# ATTACHMENT 1

## City of Ryde Submission Goodman Project Apollo Data Centre Macquarie Park

**SSD-74069708**

**Submission Date: 11 April 2025  
COR2024/131/1**

Figure 1: Markup of Incentive FSR Map (Base Source: Ryde Maps)

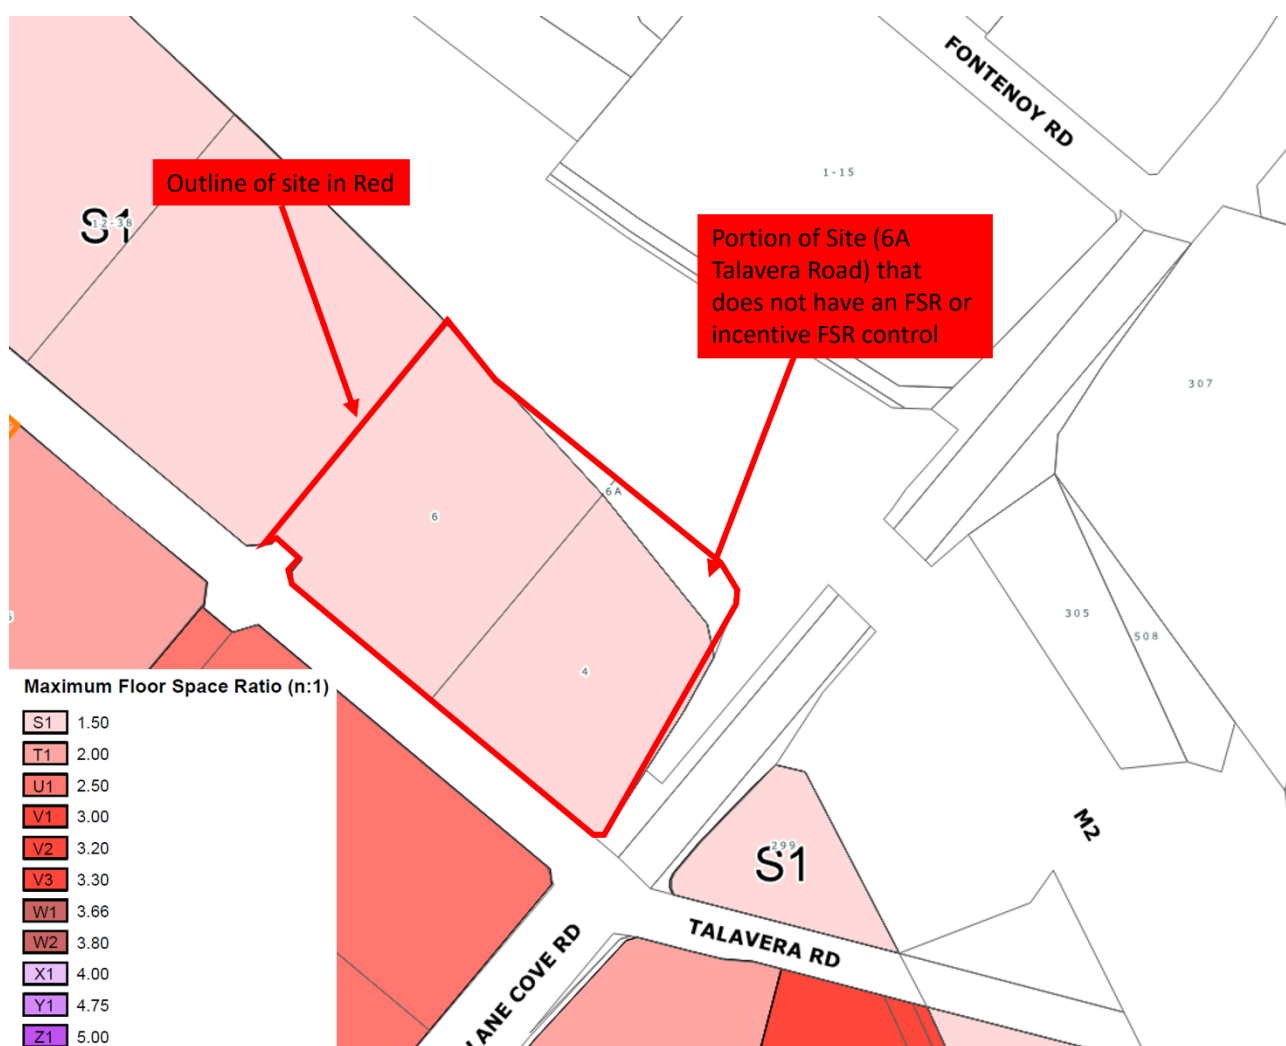
Figure 1 shows that the incentive GFA doesn't apply to the tringle splay portion of the site, which is known as 6A Talavera Road. Approx. 1453m<sup>2</sup> is to be excluded for the purposes of site area. As 6A does not have an incentive GFA on the site area, for the purposes of the VPA the site area is to exclude 6A in its calculation.

The applicant's calculation incorrectly includes a base and incentive GFA for the allotments comprising 6A Talavera Road. These allotments are not identified on the base or incentive GFA maps under RLEP and therefore cannot be included in this calculation.

The monetary contribution for the VPA should be calculated as follows:

Site area	23,180m <sup>2</sup>	Based on registered DPs of 4 and 6 Talavera (10,280m <sup>2</sup> and 12,900m <sup>2</sup> respectively). Excludes 6A Talavera.
Base GFA (1:1)	23,180m <sup>2</sup>	
Incentive GFA (1.5:1)	34,770m <sup>2</sup>	
Proposed FSR	29,668m <sup>2</sup>	As per EIS
Incentive FSR used	6,488m <sup>2</sup>	
Incentive Rate (Dec24)	\$322.48	Indexed rate in adopted Fees and Charges
<b>Total contribution</b>	<b>\$2,092,250.24</b>	Being \$322.48 x 6,488m <sup>2</sup>

*Figure 8: Image Showing Lane Cove Road Frontage (Source: Google Maps)*

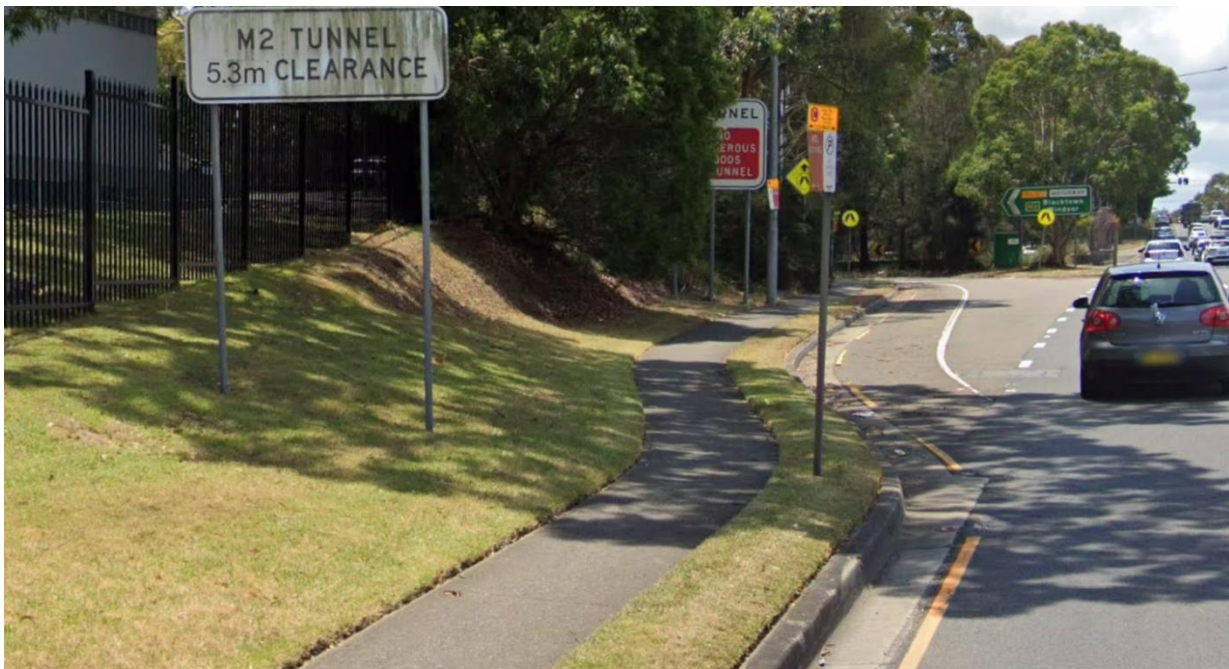
There is a significant level difference between the back of kerb and existing boundary levels along much of the Lane Cove Road frontage of the site.

As per comments for the Talavera Road frontage, the public domain upgrades required will involve significant works to address the level difference between the back of kerb and the boundary line along Lane Cove Road in order to deliver compliant public domain works (footway cross falls of 2.5%). Constructing the new granite footway and street tree pits at the required crossfall will require the construction of a significant retaining wall if the existing internal levels are to be retained directly inside the Lane Cove Road boundary line.

- Provide updated civil works plans detailing public domain works along the site frontages. The plans should address the level difference between the kerb along Lane Cove Road and

Talavera Road and detail the scope of works required to deliver the new granite footway at a compliant (2.5%) cross fall – this should be achieved by providing cross-sections along the site frontages detailing existing and proposed surface levels. The plans should detail how any level differences at the boundary interface will be managed.

Figure 10: Extract from Landscape Plan (Source: Geoscape)

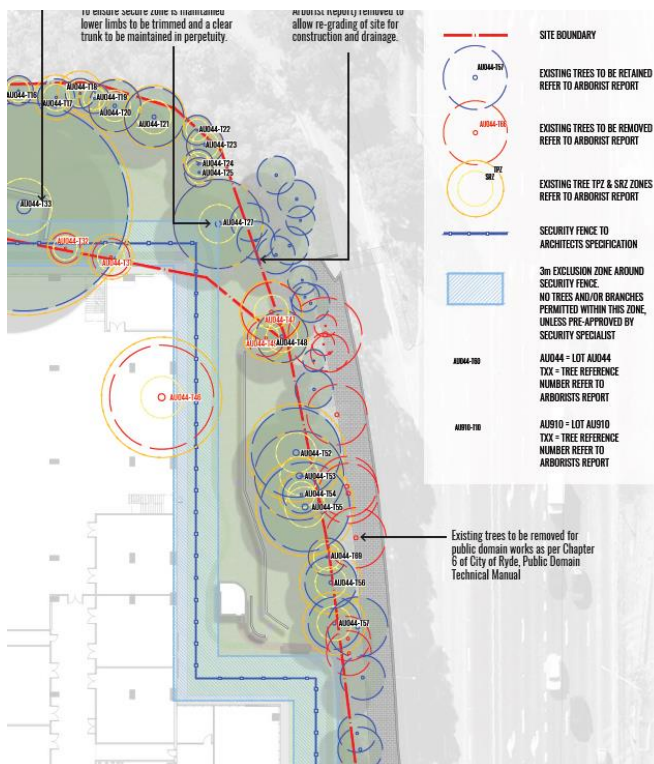
The Macquarie Park Public Domain Technical Manual specifies that full width granite between back of kerb and boundary is required along the Lane Cove Road frontage, however, this would severely impact existing street trees and internal trees as per the landscape plan below detailing trees to be removed to accommodate public domain works.

As the footway along the Lane Cove Road frontage would accommodate a relatively low volume of the pedestrian traffic. There may be an option for a less impactful arrangement, subject to review by relevant Council stakeholders. Further consultation with Council is needed on this point.

- Updated landscape plans should show the Structural Root Zone of existing street trees to be retained in relation to new retaining required along boundary alignments.
